City of Keene Planning Board

AGENDA – AMENDED

Monday, February 27, 2023

SPR-01-23 – Site Plan Review – Granite State Car Wash – 364 West Street & 12 Pearl Street

Fig 2: Front elevation (Pearl Street façade).

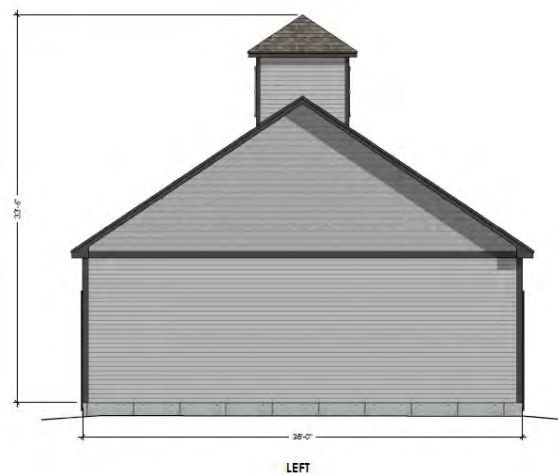
The applicant states in their narrative that the proposed carwash will be a small, 2,000 sq. ft. single story building with a pitched roof. The eastern and western facade of the building will contain two overhead doors providing access to the wash tunnels. A single passage door will provide access to the small office and mechanical room. The building walls will be made of a Nuform polymer-based block material that is waterproof. The building will be 14 ft. from the top of the foundation to the peak of the roof.

The color will be light gray. The roof will be an 8:12 pitch with asphalt shingles, also in gray. The doors and trim will be dark gray in color. A small cupola will be placed on the roof to give the building a traditional New England design that the applicant feels is appropriate for the area. The Planning Board will need to determine if this standard has been met.

SHEET LA-1

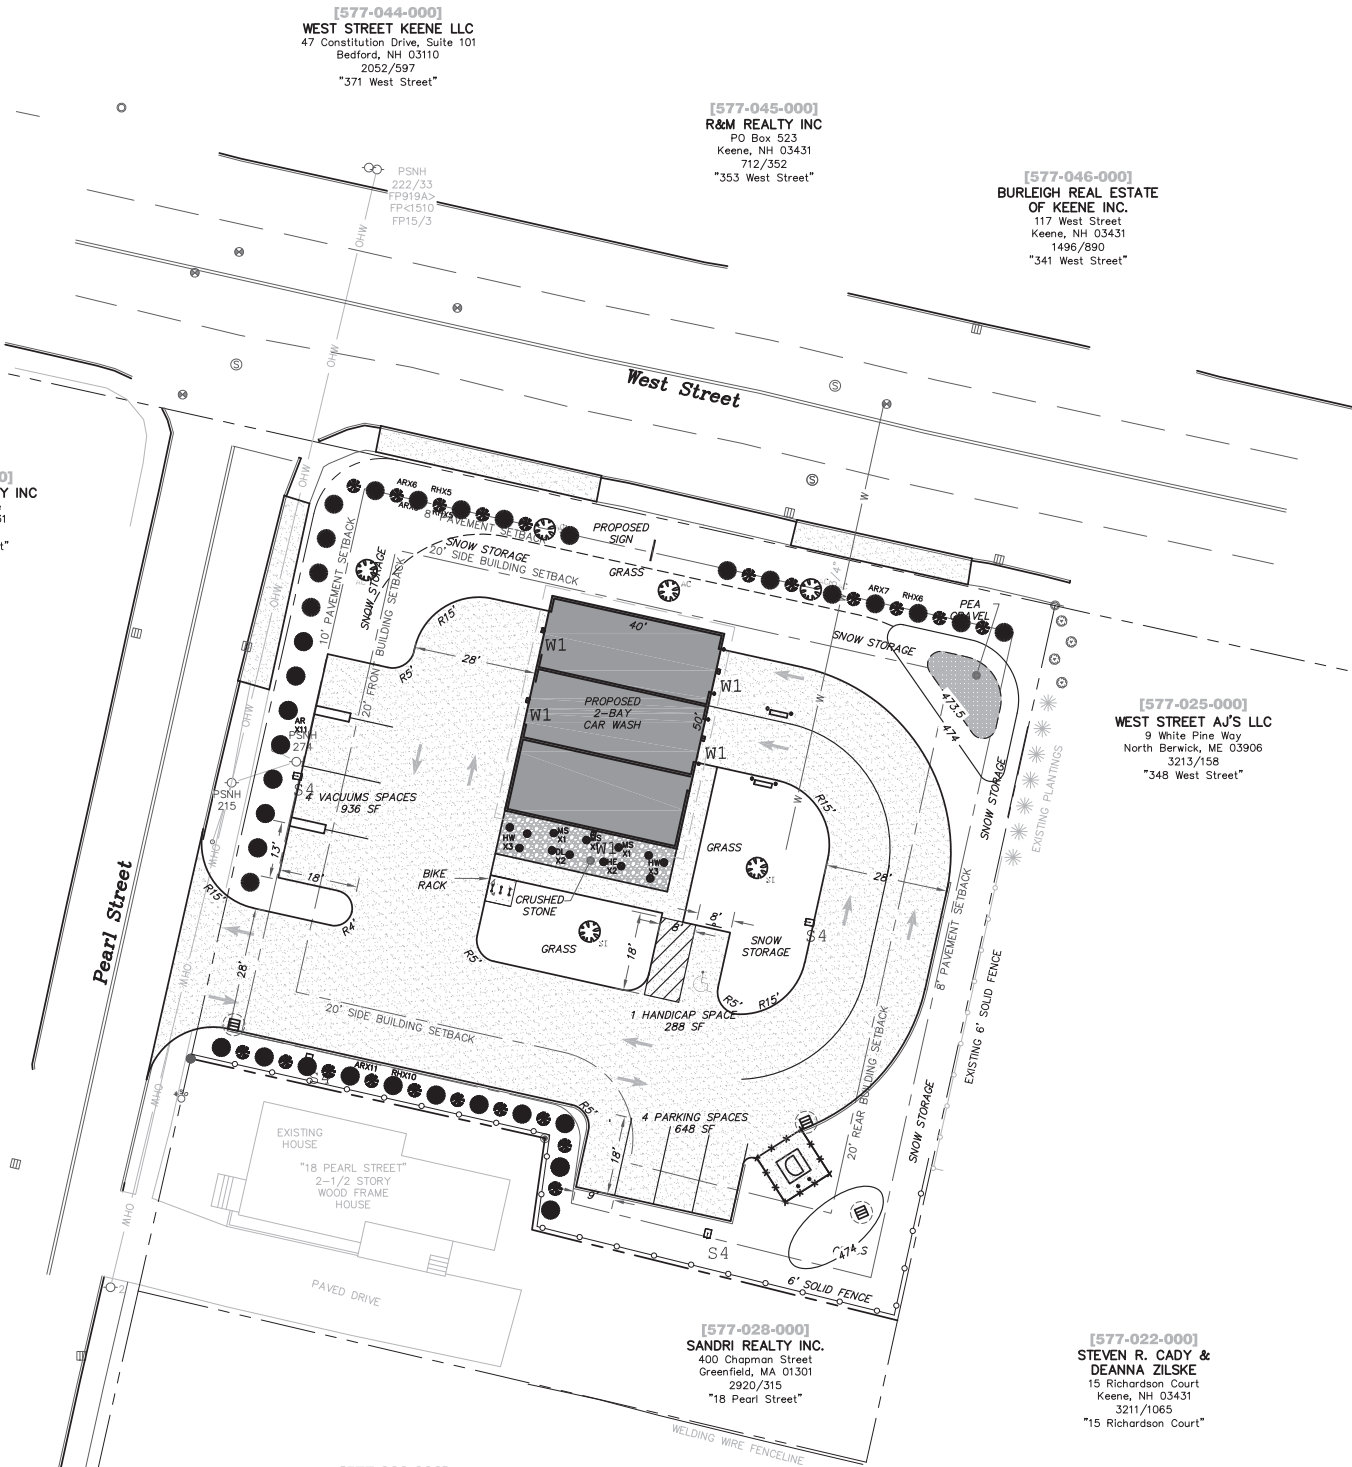
- 20.5 **Landscaping:** The Landscaping Plan, sheet LA-1 shows a selection of perennials, evergreens, and shrubs to be installed on the site. Most of the landscaping will serve as screening from the public right-of-way. An internal landscaping area is proposed along the southern façade of the building. This area will include Blue Rug Juniper, Happy Rose Daylily, and Heuchera. Rhododendron and Arborvitaes will be used for screening along the Pearl Street and West Street frontages. The proposed landscaping also includes the installation of 6 ornamental trees, 4 red leaf maples and two snowdrift crab apple trees. No invasive species are proposed. It appears that this standard has been met.

**LIGHTING
PLAN**

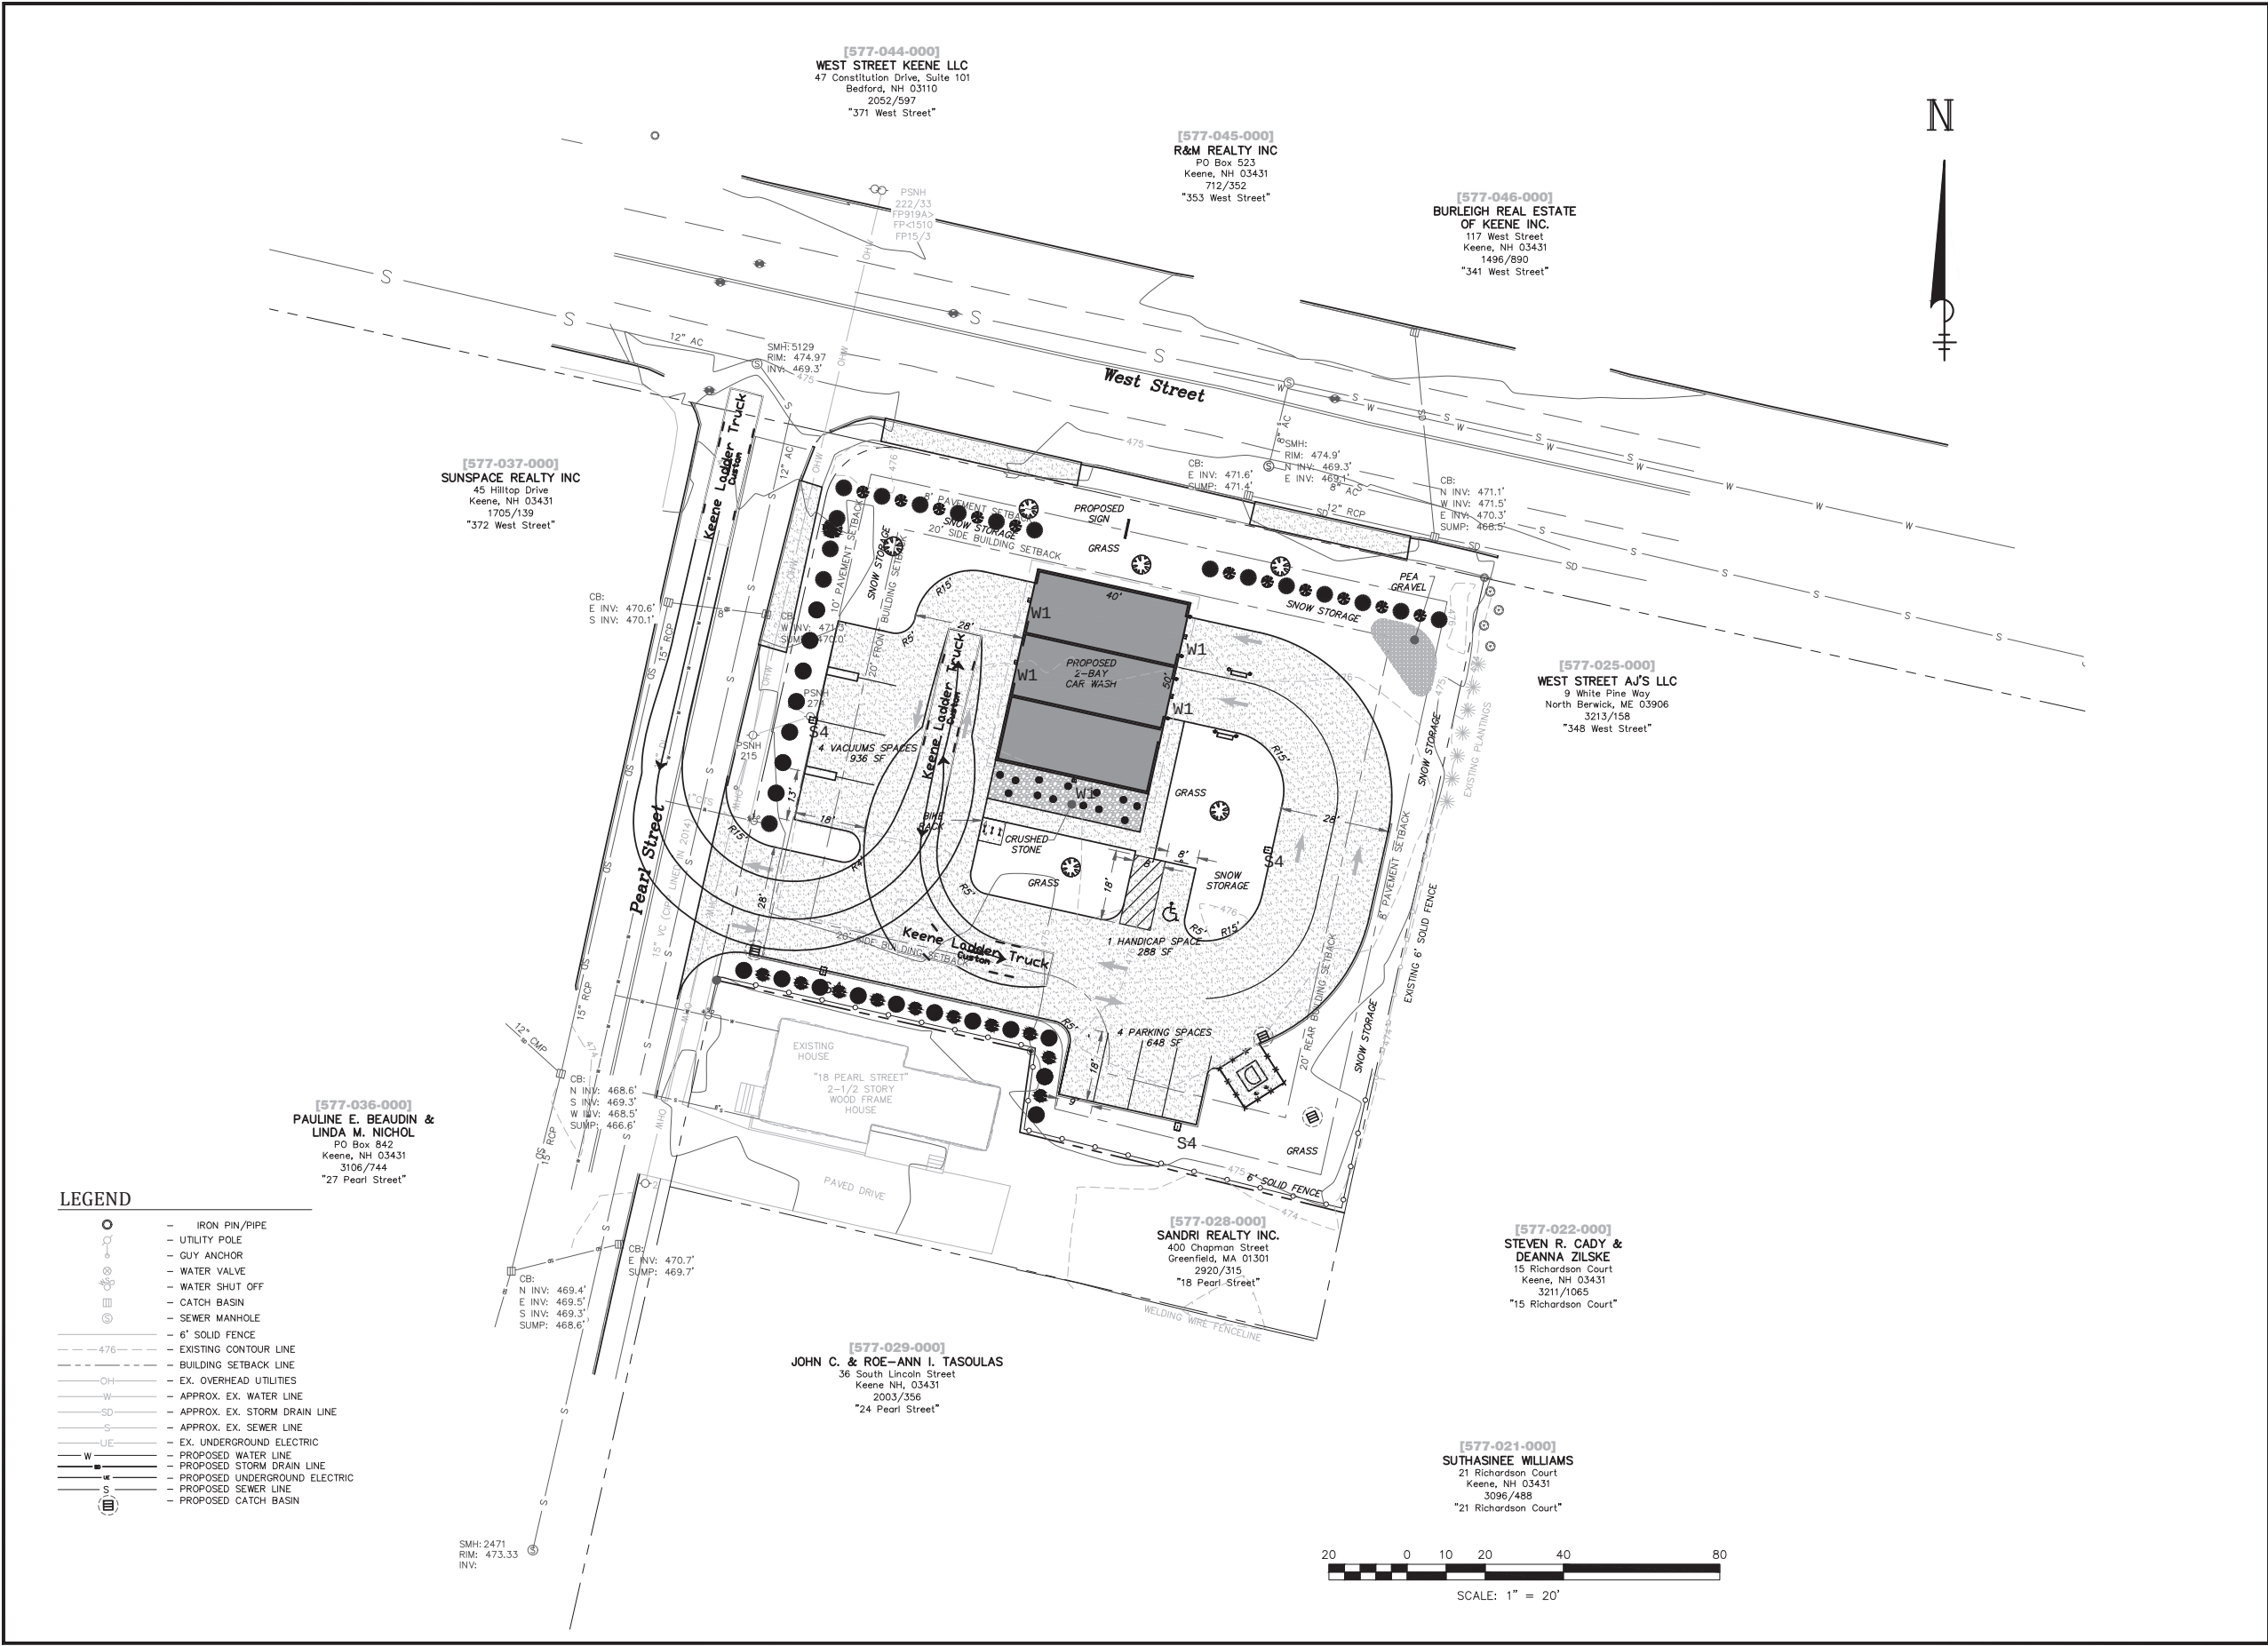
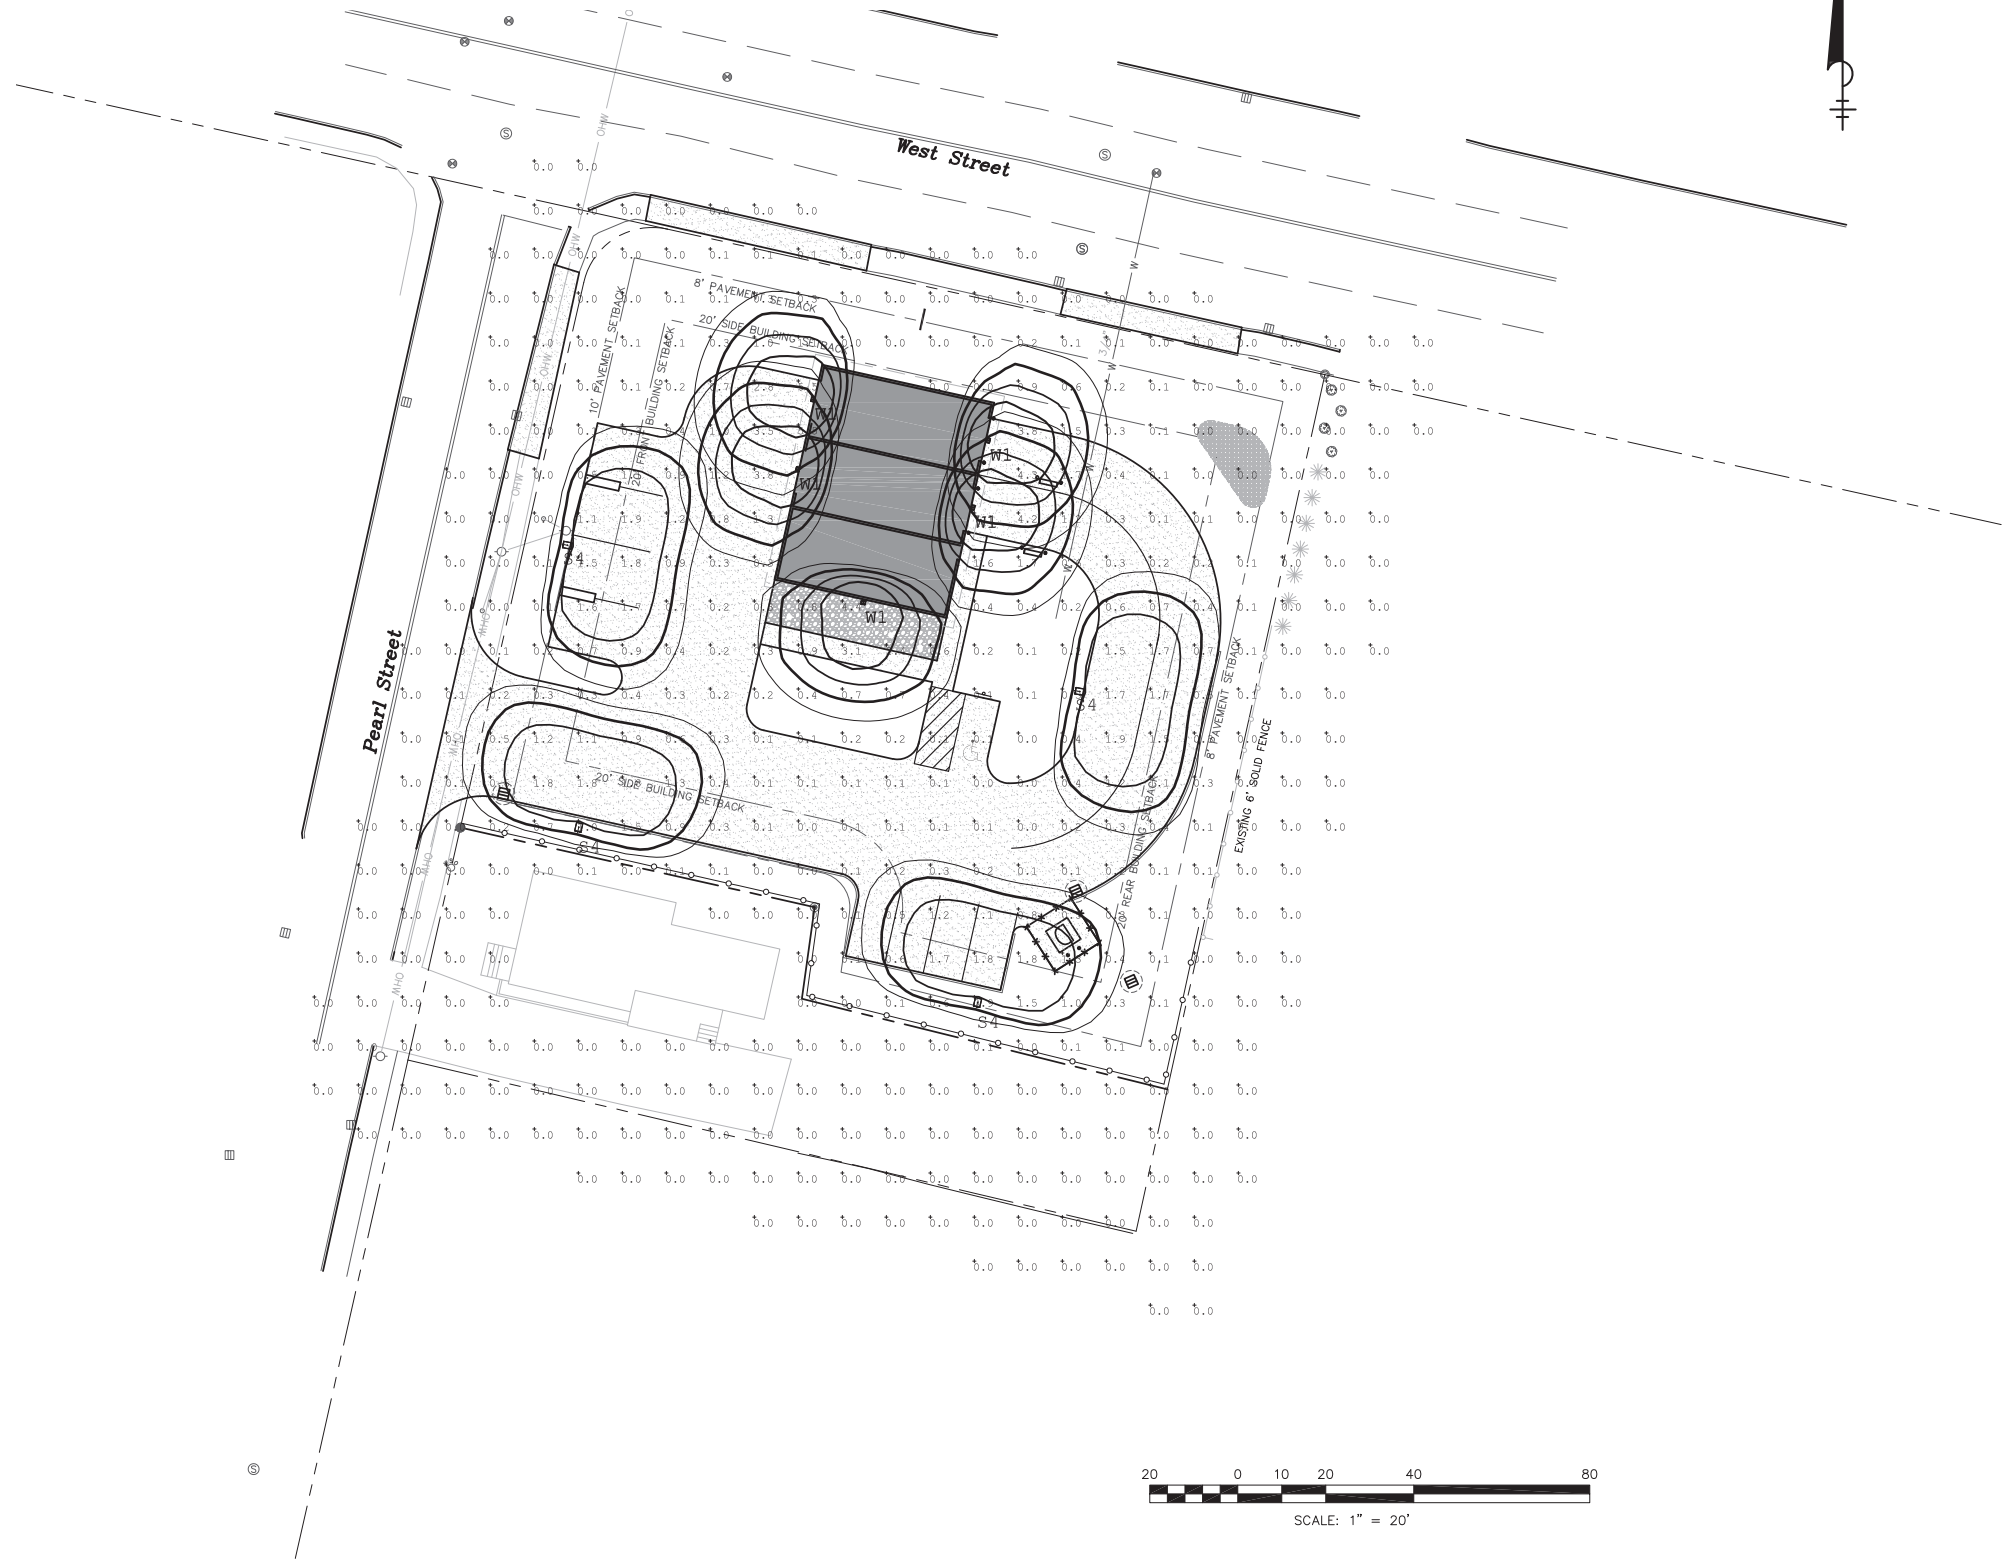
- 20.7 Lighting: The Lighting Plan, sheet LT-1 shows 4 pole-mounted lights in the parking and drive-thru area and 5 wall-mounted lights on the proposed building. The poll lights will be full cutoff LED lights mounted 15 ft. from grade. The wall-mounted lights will be full cutoff LED lights mounted 10 ft. from grade. The average light levels will be 1.32 footcandles at the vacuum stations and 1.12 at the parking spaces. The uniformity ratios are 1.89:1 and 2.24:1 where the standard requires the ratios to not exceed 5:1.

The applicant has submitted a waiver request to provide relief from Section 20.7.3.F.1.c of the Land Development Code, which states, “For 24-hour businesses, lighting levels shall be reduced by a minimum of 50% between the hours of 10:00 pm and 6:00 am.” The applicant states in their waiver request that reducing the light levels below 1 footcandle would create a potentially hazardous condition as the carwash will operate 24-hours and they expect customers after 10 PM.

Strict conformity results in an unnecessary hardship for the Owner. The proposed lighting plan calls for average light levels at 1.32 footcandles at the vacuum stations and 1.12 footcandles at the parking spaces. These are very low levels and reducing the levels by 50% would result in unsafe lighting conditions on the site. The carwash operates 24 hours per day and will have customers after 10:00 PM. Reducing light levels below 1 footcandle would create a potentially hazardous condition. This is an unnecessary hardship for the owner.

Specific circumstances of the site plan will meet the spirit and intent of the standard. The proposed light levels are very low at 1.32 and 1.12 footcandles, just slightly exceeding the recommended security level lighting of 1 footcandle. These are full cutoff LED fixtures and will provide uniformity ratios between 1.89:1 and 2.24:1 where a maximum of 5:1 is permitted. The intent of the standard is to provide safe lighting without excessive light into the night sky or onto abutting properties. This proposal meets the intent of the standard.
